FEDERAL COMMUNICATIONS COMMISSION

**MEDIA BUREAU
AUDIO DIVISION**

In re: K245AU, East Quincy, CA
BPFT-20160729AFX
Facility ID # 151371

THE FOLLOWING IS A LIST OF THE DATA WHICH APPEARS ON THE ABOVE MAP

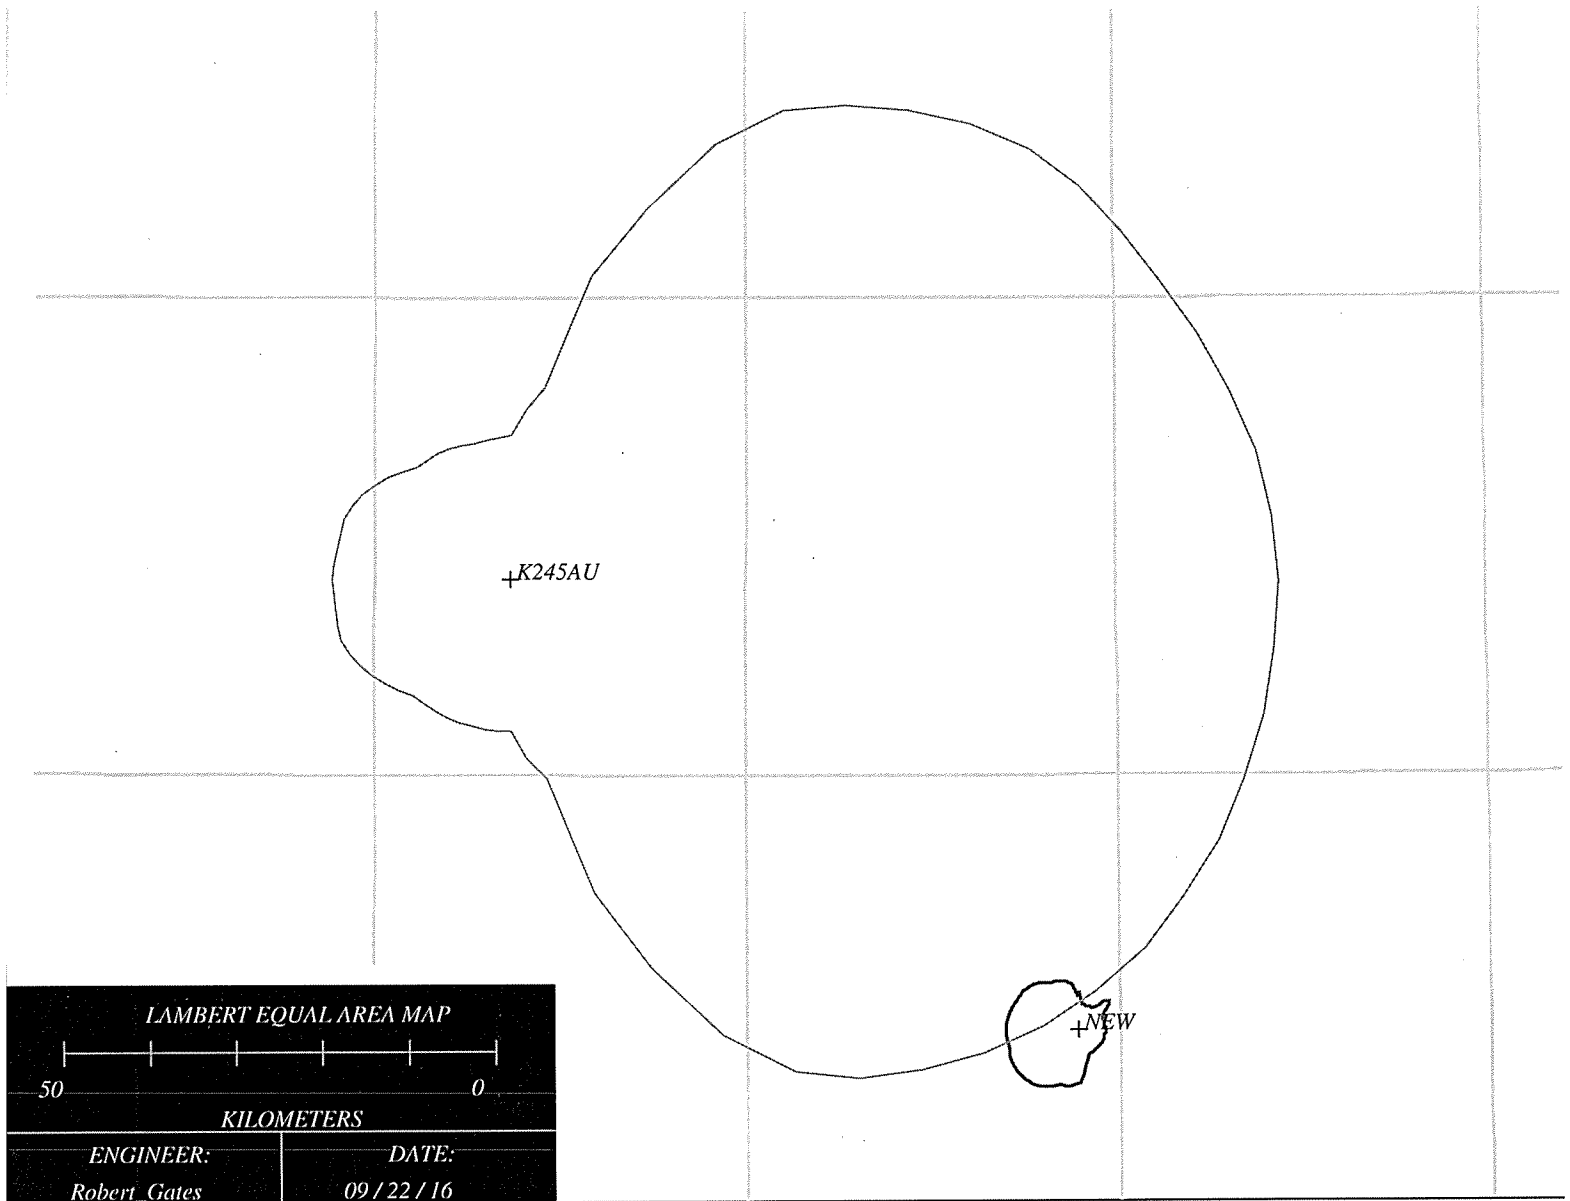
An engineering study has revealed the application violates 47 C.F.R. § 74.1204(a) with respect to a new LPFM for El Dorado, CA (BNPL-20131114BWC). Section 74.1204(a) states that an application for a FM translator station will not be accepted if the proposed operation would involve prohibited overlap of predicted field strength contours with any other authorized station. The proposed 40 dBu interference contour overlaps with the 60 dBu protected contour of the LPFM for El Dorado, California. This violation was not addressed.

In light of the above, the application BPFT-20160729AFX is unacceptable for filing pursuant to 47 C.F.R. § 73.3566(a) and IS HEREBY DISMISSED. This action is taken pursuant to 47 C.F.R. § 0.283.
